# Access Compliance Report

## Public Rights-of-Way

Intersection ID: 26793	Main Street: JAMES_VALLEY_CT	Cross Street: MANOR_HOUSE_DR	Location: S
ADA ID: 4A82AFCD2848	Ramp Type: Perp	Initial Pass/Fail: Fail	Overall Compliance: No
		Severity Score: 8.75

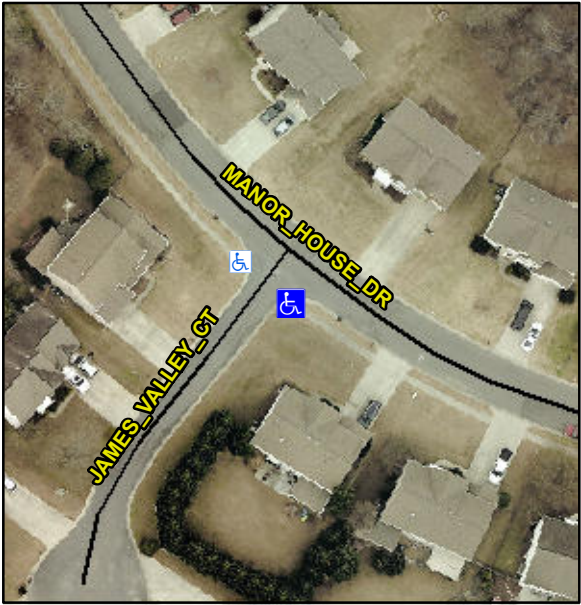
Codes/Mitigation Info/Possible Solution		Field Measurements/Component Compliance			
	<p>Possible Solutions:</p> <p><b>Remove &amp; Replace Entire Ramp.</b></p>	<p>Surveyor Notes:</p> <p><b>N/A</b></p>	<p>PROW/ADA:</p> <p><b>Not Found, R304.5.1</b></p>	<p>Total Cost:</p> <p><b>\$ 1850.00</b></p>

Compliance	Description	Data	Compliance	Description	Data
N/A	Ramp Length (in)	32.5	Yes	Ramp Slope (%)	5.8
No	Ramp Width (in)	46.0	Yes	Ramp XSlope (%)	1.6
N/A	Flare Type LT	N/A	N/A	Flare Type RT	N/A
N/A	Flare Slope LT (%)	N/A	N/A	Flare Slope RT (%)	N/A
N/A	Flare Traversable LT?	N/A	N/A	Flare Traversable RT?	N/A
N/A	Landing Length (in)	N/A	N/A	DWS Provided?	N/A
N/A	Landing Width (in)	N/A	N/A	DWS Contrast?	N/A
N/A	Landing Slope (%)	N/A	N/A	DWS Length (in)	N/A
N/A	Landing X Slope (%)	N/A	N/A	DWS Full Width?	N/A
N/A	Landing Curb? (Y/N)	N/A	N/A	DWS Offset (in)	N/A
N/A	Shared Landing?	N/A			
N/A	Gutter Ponding?	N/A	N/A	Gutter Slope (%)	N/A
N/A	Gutter Lip Ht (in)	N/A	N/A	Gutter X Slope (%)	N/A
N/A	Painted X Walk1?	No	N/A	Painted X Walk2?	N/A
	X Walk 1 Direction	To NW		X Walk 2 Direction	N/A
N/A	X Walk 1 Width (in)	N/A	N/A	X Walk 2 Width (in)	N/A
	X Walk 1 Slope (%)	1.4		X Walk 2 Slope (%)	N/A
	X Walk 1 X Slope (%)	3.4		X Walk 2 X Slope (%)	N/A
